## PLANNING DIVISION STAFF REPORT

711-719 Jenifer

Certificate of Appropriateness for land division in a historic district

Legistar File ID#

Third Lake Ridge historic district map showing the approximate location of the proposed property line at 719 Jenifer related to the existing context of lot size patterns.

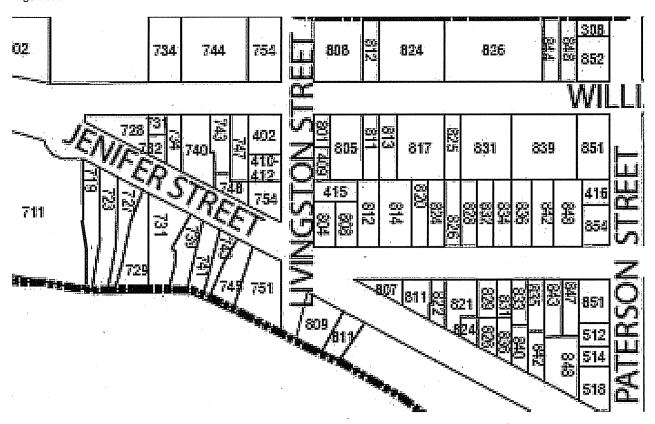
The Landmarks Commission reviewed the land division request at their meeting of August 22, 2016. After public testimony and review of the Ordinance standards, the Commission referred their action on the land division request to a future meeting. The referral was made to allow the property owner time to revise the request so that the residential property could maintain access to the lake and therefore also maintain the historic patterning of lots on the south side of Jenifer Street in the historic district.

The Elks intend to divide their existing lot to make two lots. One lot would contain all of the improvements related to the Elk's Lodge and the other lot would contain the historic residence. The Elks revised the lot being created for the historic residence so that it has a portion that extends to the lake. The property line was drawn to allow exterior improvements of the Elks Lodge to remain in place. This configuration is similar to other adjacent residential lots and maintains the patterning of lots on the south side of Jenifer Street in the historic district.

Staff believes that the standards for granting a Certificate of Appropriateness for the land division are met and recommends that the Landmarks Commission approve the Certificate of Appropriateness.
